UNITED STATES PATENT AND TRADEMARK OFFICE

APPLICATION NO.	FILING DATE	FIRST NAMED INVENTOR	ATTORNEY DOCKET NO.	CONFIRMATION NO.
10/517,735	08/08/2005	Ian Richard Webb	3700.P0388US	5929

Office Action Summary

DETAILED ACTION

(Straub Figures 1-5)

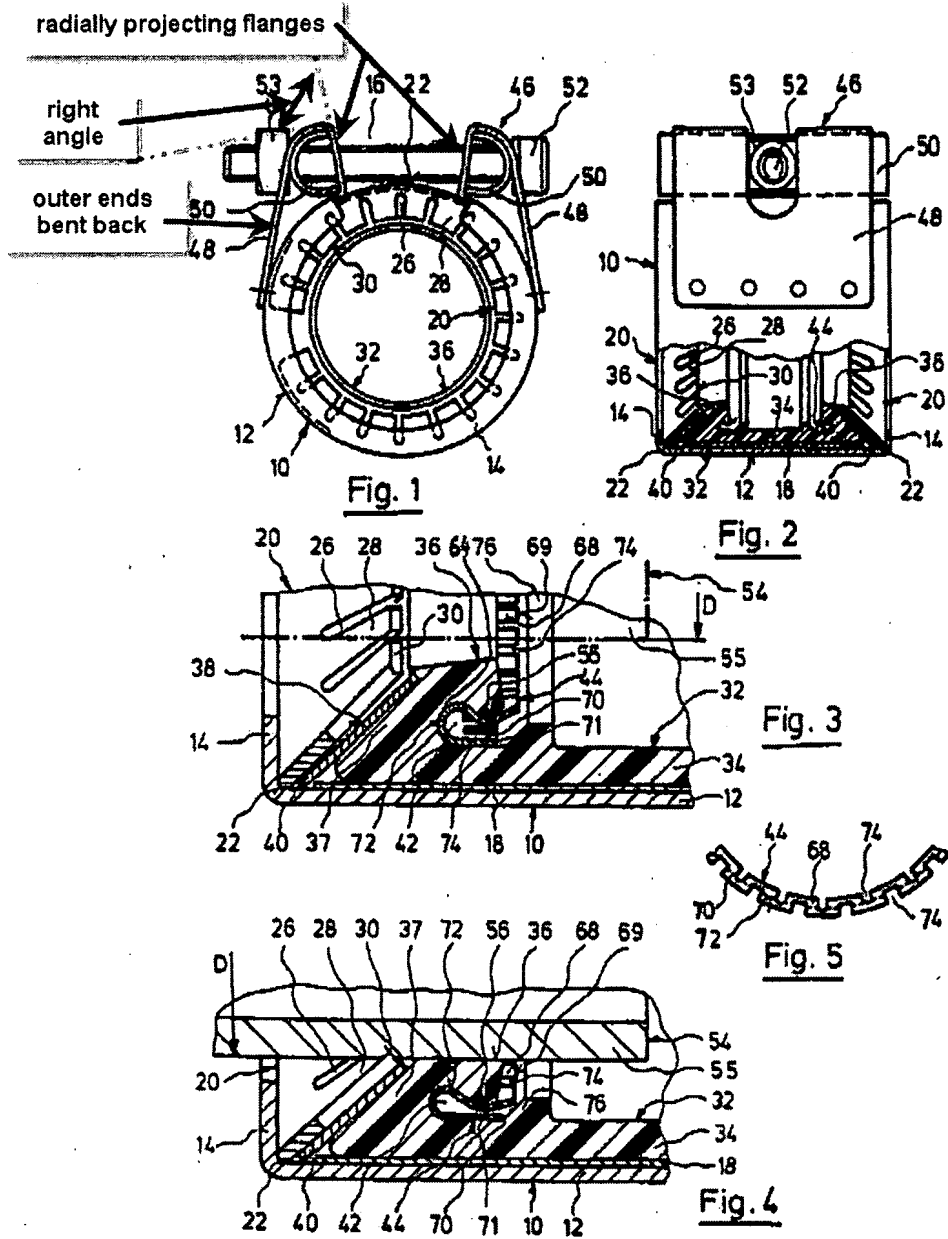
In regard to claim 10, Straub, in Figures 1-5, below, discloses a pipe coupling for connecting together the ends of two pipes, comprising:

a tubular casing (10) having circumferentially extending end flanges (14) projecting inwardly from the axial ends of the casing,

a tubular sealing sleeve (32) inside the casing;

tensioning (52 and 53) means for tightening the casing around the sealing sleeve; and

frustoconical gripping rings (44) located within the casing at opposite ends of the casing, the inner edges of the gripping rings being formed with teeth (68);

the casing comprising a strip of metal formed into a tube with a gap (as observed in Figure 1) extending longitudinally of the casing between the free ends of the strip;

the tensioning means interconnecting the free ends of the strip;

the arrangement being such that when the coupling is placed around the ends of two pipes to be connected and the tensioning means are tightened, the casing presses the sealing sleeve against the pipe ends to form seals and forces the teeth on the gripping ring to bite into the surface of the pipes to grip the pipes,

wherein the free ends of the strip are bent outwardly to form radially projecting flanges extending longitudinally of the casing on opposite sides of the gap, the two radially projecting flanges being placed between two reinforcing members (50) which extend substantially the length of the coupling, the tensioning means passing through sets of aligned holes in the reinforcing members and the radially projecting flanges, the reinforcing members each having an angled cross-section (the reinforcing members are U-shaped - column 3, lines 8-9 - and, therefore, there is an angle formed by the junction of the straight sides and the curved portion as shown in Figure 1 cutout, below) of the , a web portion (shaded in Figure 1 cutout, below) through which the holes for the tensioning means pass, and a reinforcing flange extending along the longitudinal edge of the web portion that is nearer to the axis of the coupling, the reinforcing member flange bearing against the tubular portion of the casing (as observed in Figure 1, see Attachment A, the noted "reinforcing member flange" appears to abut the surfaces of the indicated corner. Simple contact meets a broad definition of "bearing").

In regard to claim 16, Straub further discloses that the aligned holes are elongated in the radial direction (as observed in Figure 2).

In regard to claim 17, Straub further discloses a backing rings (parts 40 in Figure 3, above) provided inside the casing adjacent a respective gripping ring (44) between the gripping ring and the sealing sleeve (32) to prevent the sealing sleeve from bulging between the teeth of the gripping ring.

(Straub Figure 1 cutout)

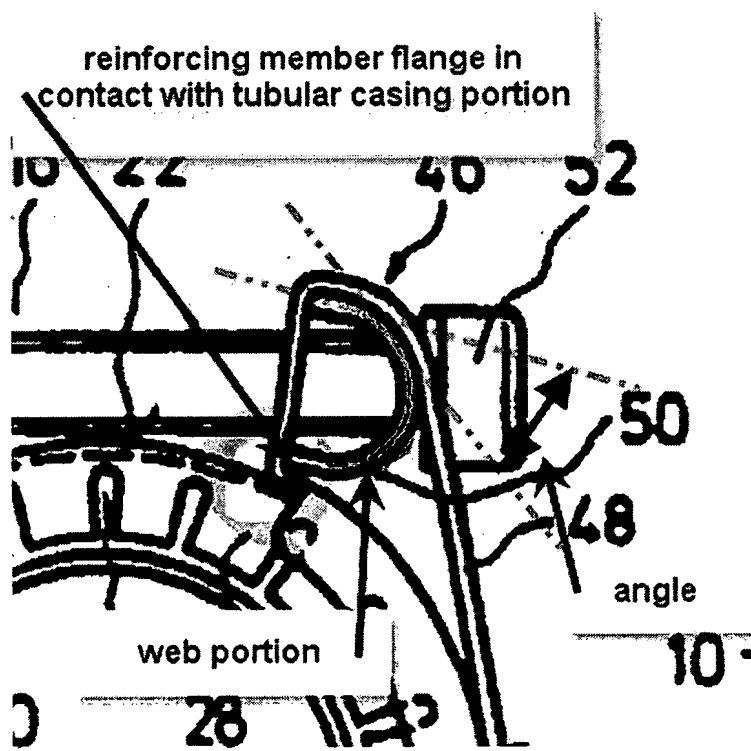
In regard to claim 11, as best understood, Straub further discloses that each reinforcing member has a channel-shaped cross section with reinforcing member flanges (the straight sides of the U-shape) extending transversely along both longitudinal edges of the web portion (as observed in Figure 1 cutout, above).

In regard to claim 19, Straub further discloses that the outer ends of the radially projecting flanges are bent back in a transverse direction to form planar stiffening flanges (as observed in Figure 1, above) along the longitudinal outer edges of the radially projecting flanges.

In regard to claim 20, Straub further discloses that the radially projecting flanges are bent back at right angles (as observed in Figure 1, above).

ATTACHMENT A

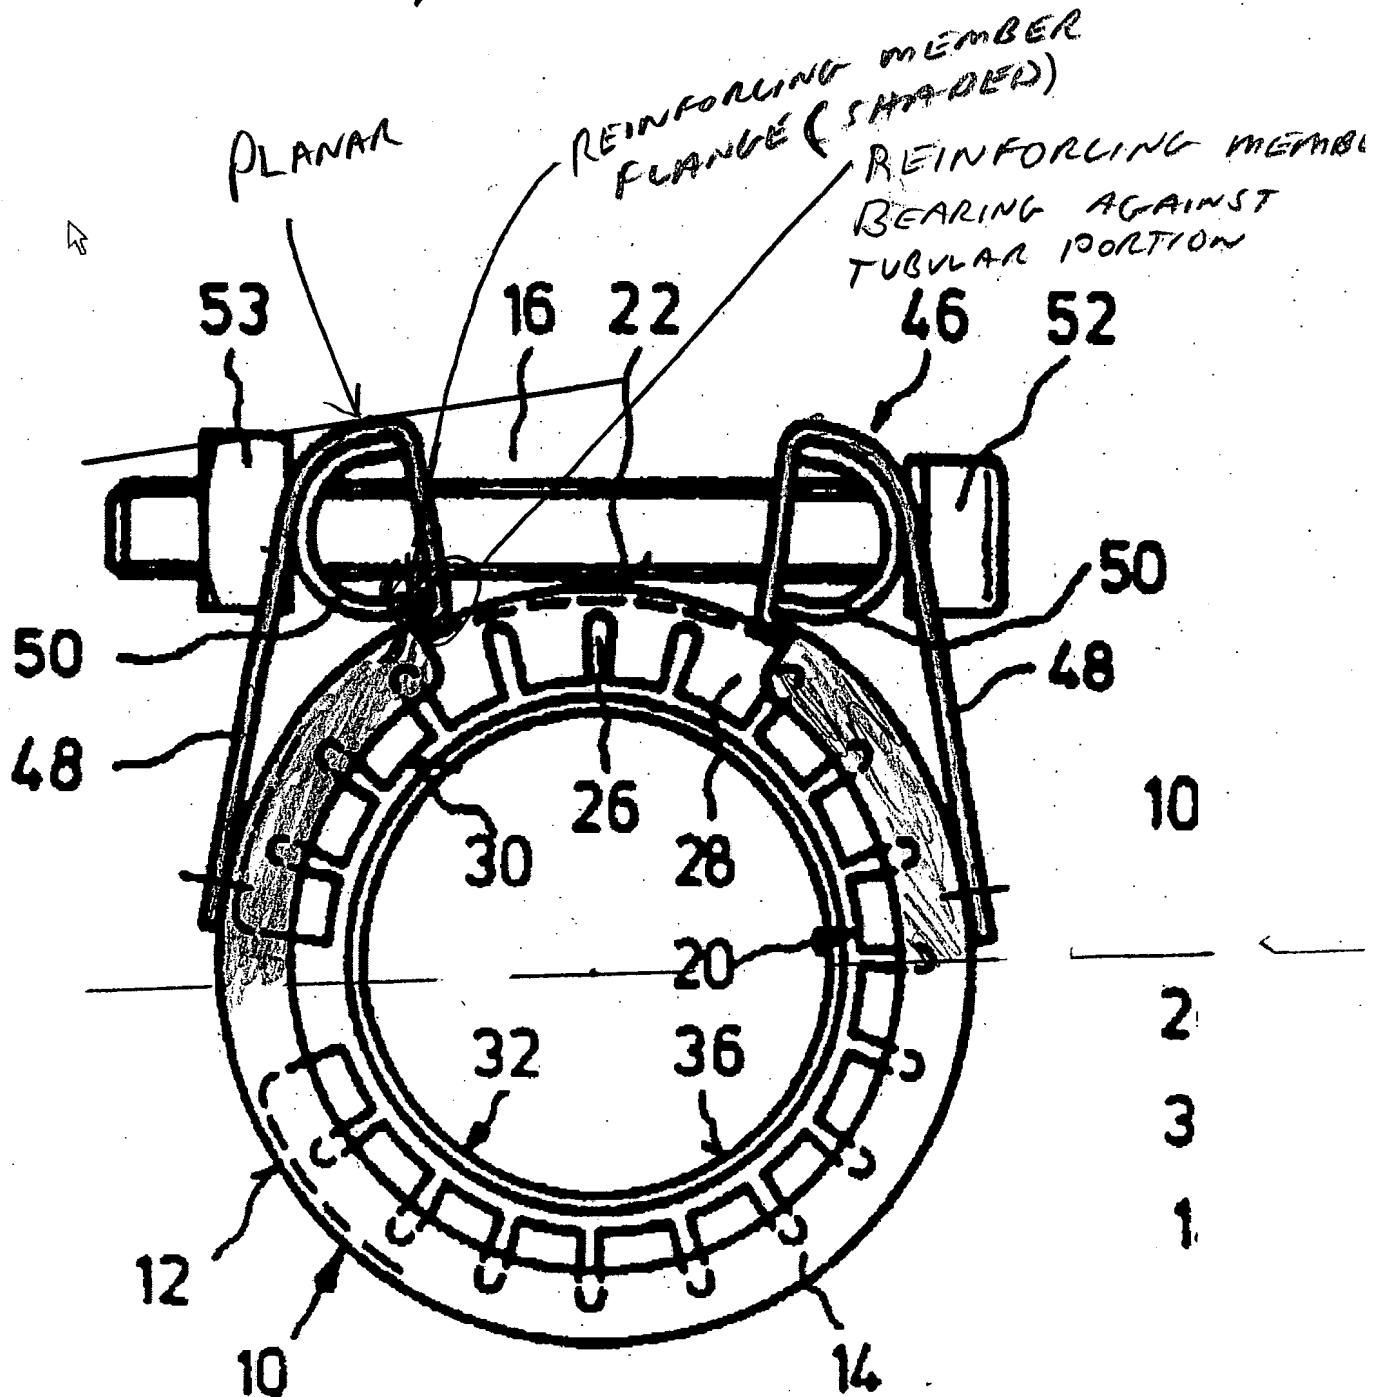
Concerning the Applicants' assertion in page 13, lines 4-6, of the reply filed 09/10/2007 that the prior art of Straub (U.S. 5,273,322) does not disclose a strip with a free end in regard to claim 10, the argument is not persuasive. The phrase "free end", given a broad definition, simply indicates an end that is free to move, not connected to the whole. The phrase "free end" indicates no specific structure and the phrase "free end" does not preclude any constituent structure, such as having loops. As shown in Figure 1, see Attachment A, the tubular casing of Straub does have two free ends, else how could the structure be tightened around two pipe ends? If the "free-end" of the prior art is not as the Applicants intended, then the Applicants should recite in the claims that structure which the Applicants do intend the phrase "free end" to indicate and thereby overcome the prior art of Straub.

Concerning the Applicants' assertion in page 13, lines 7-13 of the reply filed 09/10/2007 that the prior art of Straub (U.S. 5,273,322) does not disclose the reinforcing member flange bearing against the tubular portion of the casing. First, nowhere in the claim is it defined as to what constitutes the tubular portion of the casing; therefore, any arbitrarily portion that is a constituent of the tubular casing may be deemed to meet the "tubular portion" limitation since the whole casing, including any constituent elements and portions, is recited as being "a tubular casing" in claim 10, line 2. Further, as observed in Figure 1, see Attachment A, the noted

“reinforcing member flange” appears to abut the surfaces of the indicated corner. Simple contact meets a broad definition of “bearing”.

Concerning the Applicants' assertion in page 13, lines 7-13 of the reply filed 09/10/2007 that the prior art of Straub (U.S. 5,273,322) does not disclose the outer ends of the radially projecting flanges “bent back to form ‘planar stiffening flanges’”, the argument is not persuasive. As can be clearly observed in Figure 1, see Attachment A, the outer ends of the radially projecting flanges are “bent back to form ‘planar stiffening flanges’”.

SHADED AREAS ARE "FREE ENDS"
